Product Change Notice (PCN)

Subject: Marking Change on Intersil TW6869-TA1-CRH Product

Publication Date: 9/27/2016

Appendix A – Package Top side marking (see attached)

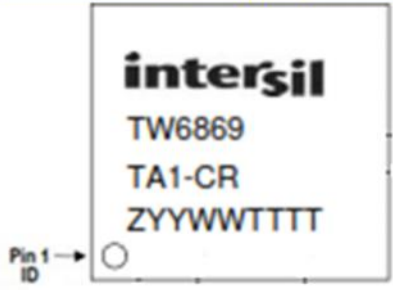
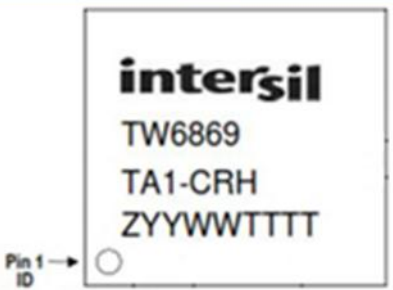
Marking Change of TW6869-TA1-CRH from “TW6869-TA1-CR” to “TW6869-TA1-CRH”

The letter “H” will be added to the top side marking and device data sheet. The letter “H” is an indication for device which tested at hot temperature. Please refer Appendix A for details of marking change.

From	To
Product part number	TW6869-TA1-CRH	TW6869-TA1-CRH
Package top side marking	TW6869-TA1-CR	TW6869-TA1-CRH
Package type	144 Lead TQFP (20mm x 20mm x 1.1mm)	144 Lead TQFP (20mm x 20mm x 1.1mm)
